MDPGA Wethersfield Response to further information request

Town & Country Planning (Environmental Impact Assessment) Regulations

ANNEX A: DLUHC further information request: MDPGA Wethersfield – Applicant's response

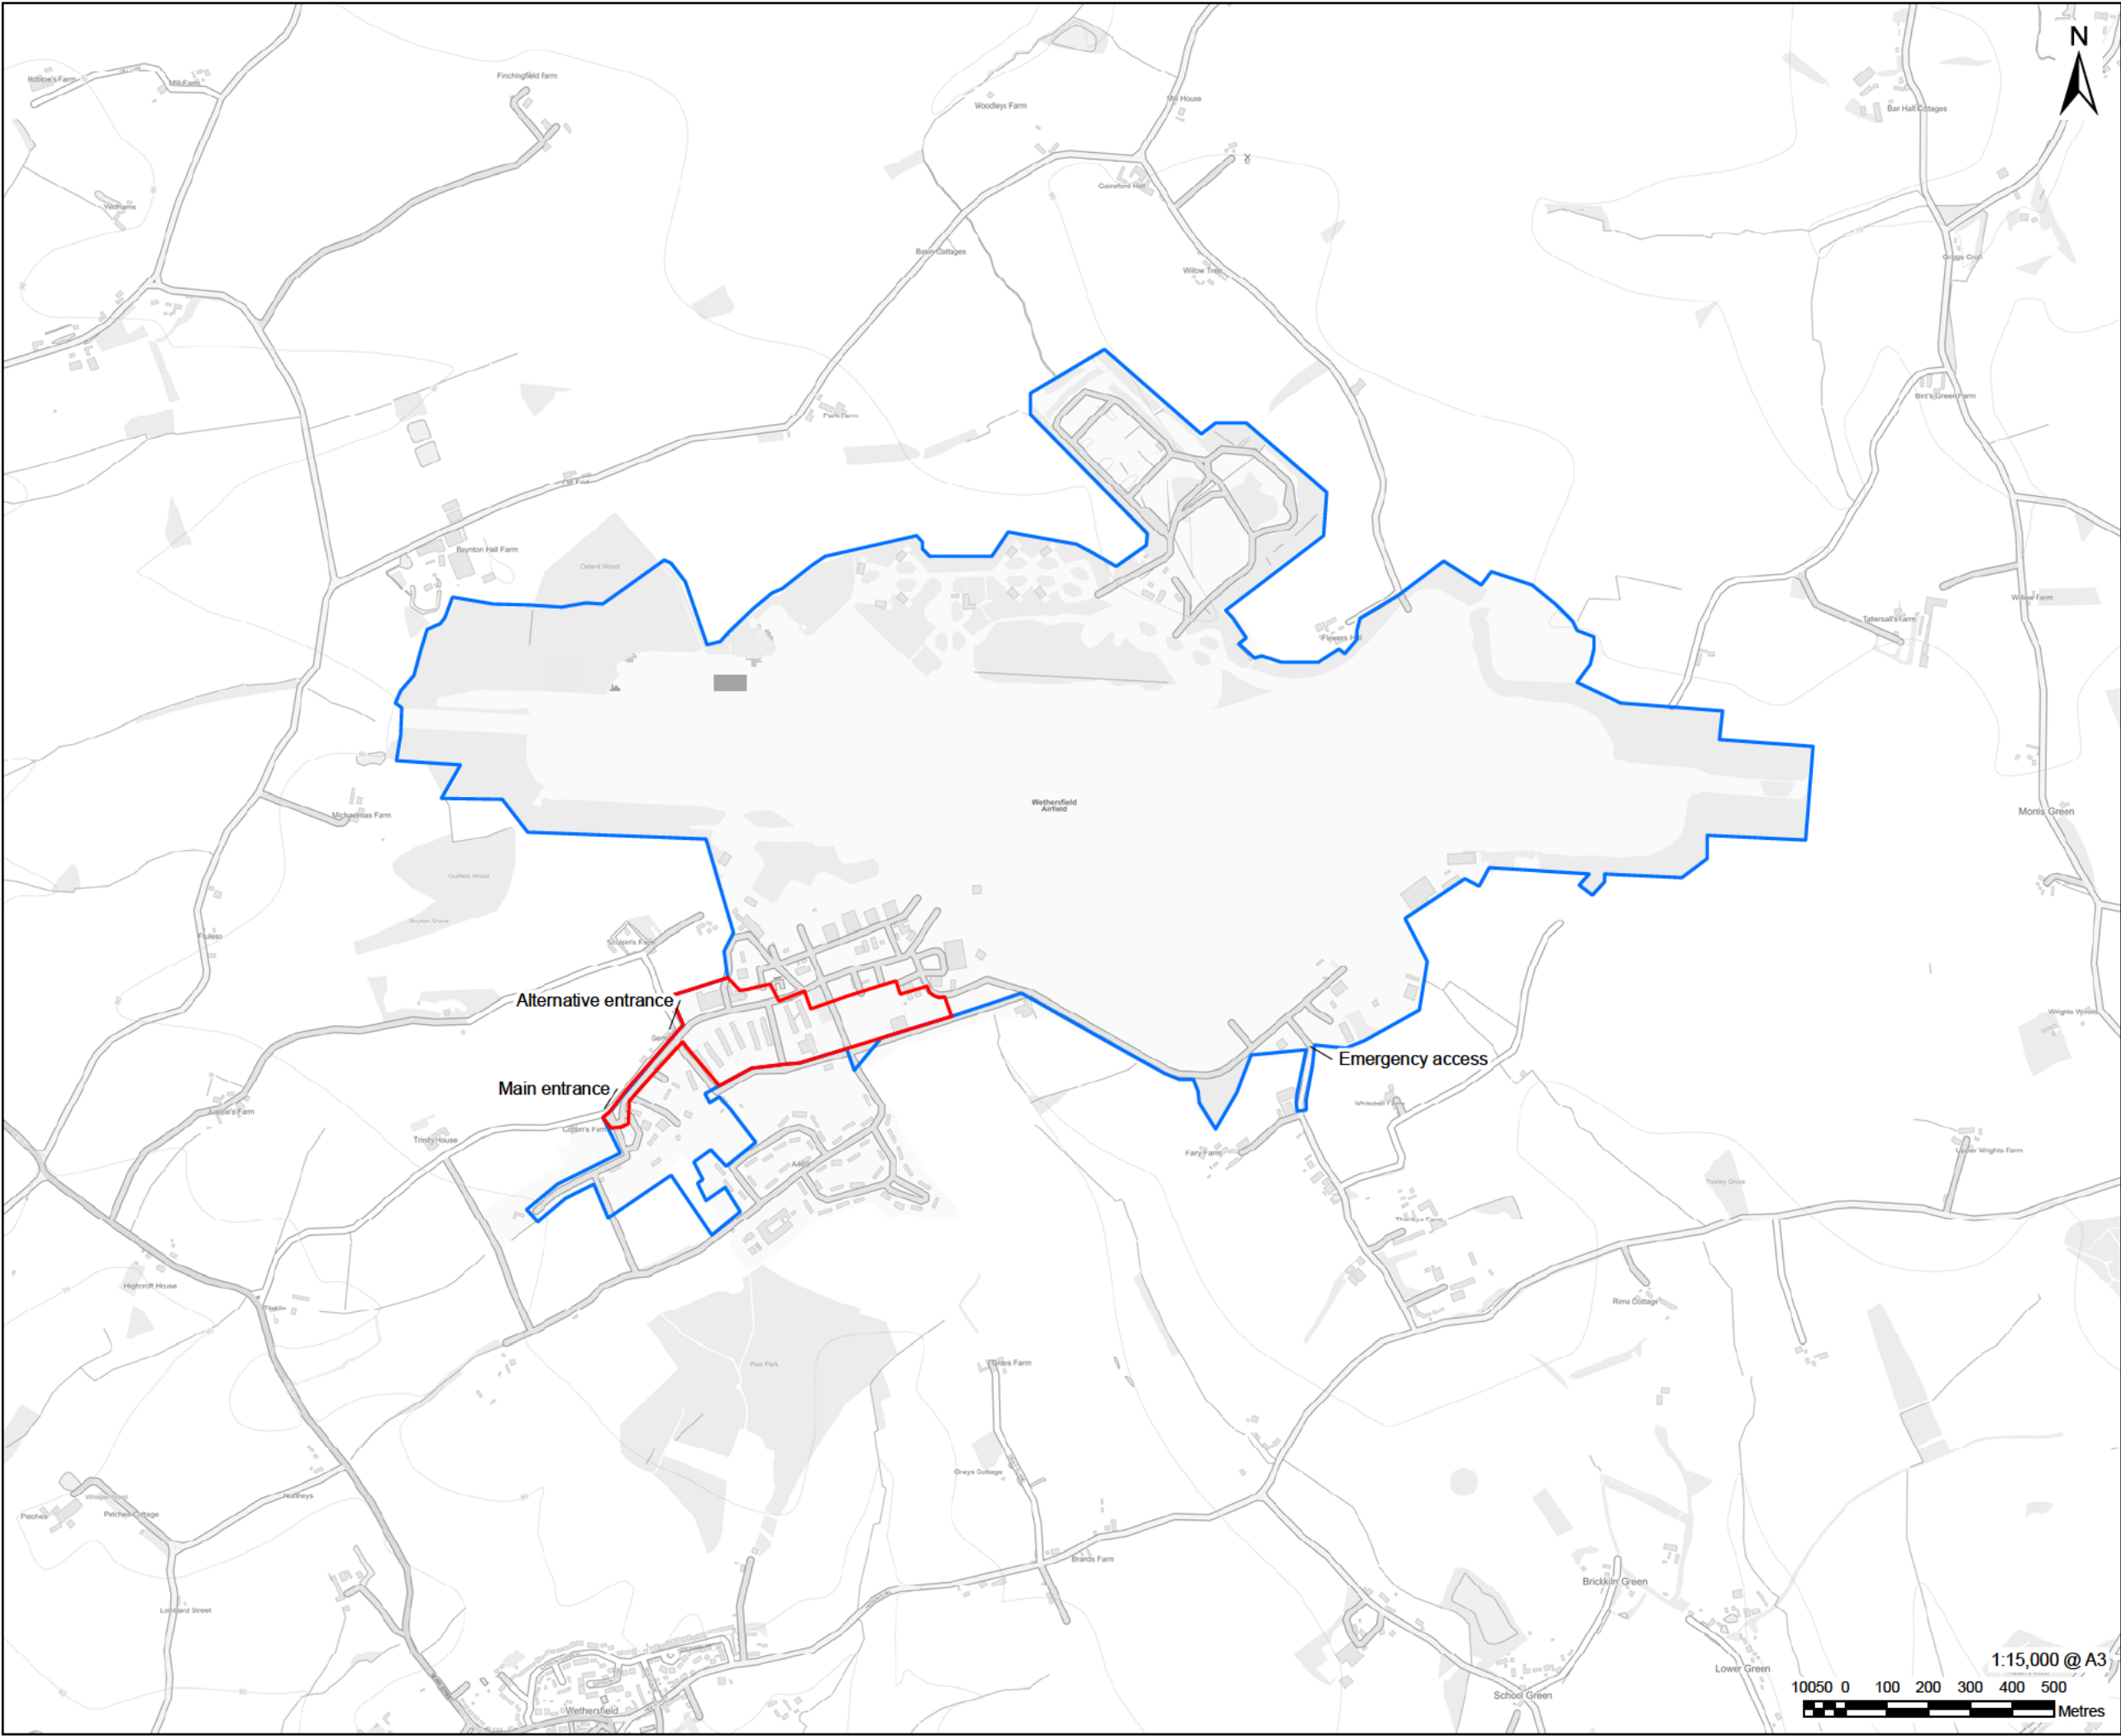
Figure 1	Alternative entrance to the Development Site	<p>1. Please clarify whether this alternative entrance will be used, and what assumptions, if any are included in the transportation assessment.</p>	<p>The alternative entrance will be used by service users entering the Site. A modular security office will be erected at this entrance to provide accommodation for security staff.</p> <p>The main entrance will continue to be used to access the SFA properties and access to the wider MDPGA facility.</p>
Supplementary information relating to the description of development (addiitonal to Section 2 in the Screening Request letter dated 17 th March 2023)
